Construction Division
Additions & Alteration Charges Approval Form

Quality Control Check Report. Stage: After Plumbing & Electrical (Apartments)

GULMOHAR RESIDENCY

Details of Additions & Alterations

Changes in flooring:

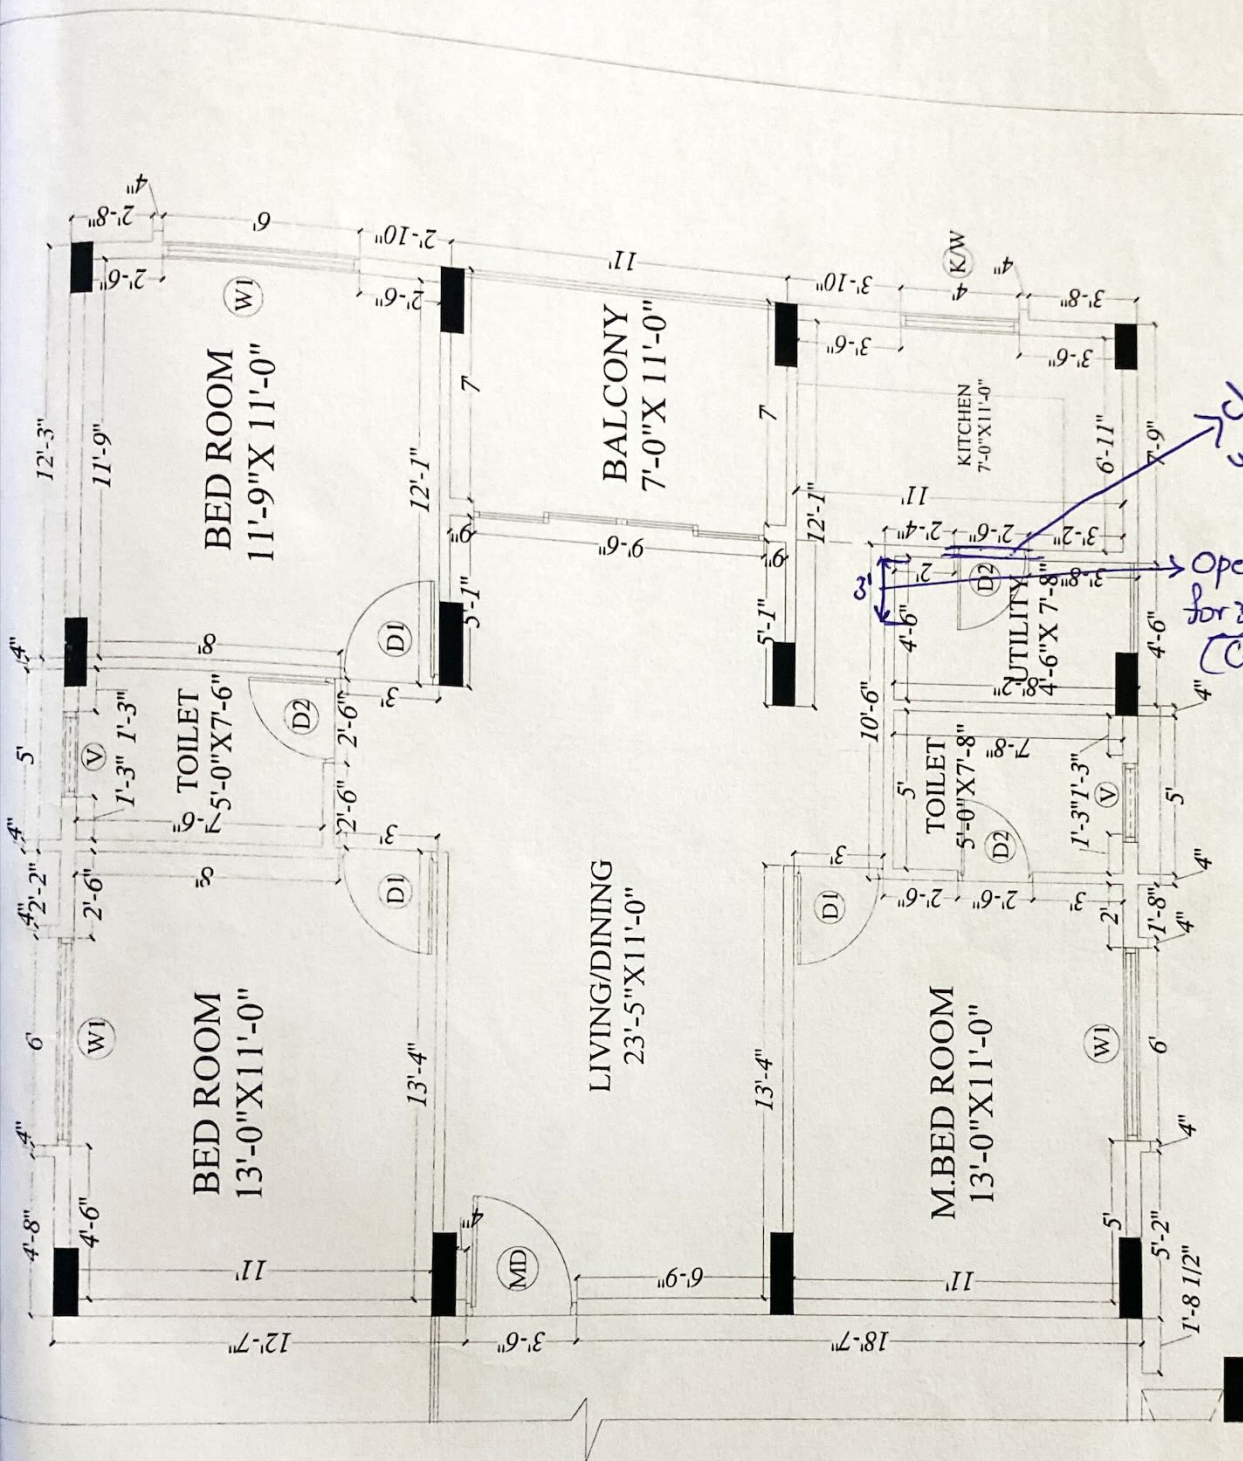
- ① ~~Star~~ Master Bed room - Urban wood natural
- ② Hall & Dinine - Regal Beige.
- ③ Kitchen. - As Default (Country Almond)
- ④ children & Guest Bed room - Regal Beige.
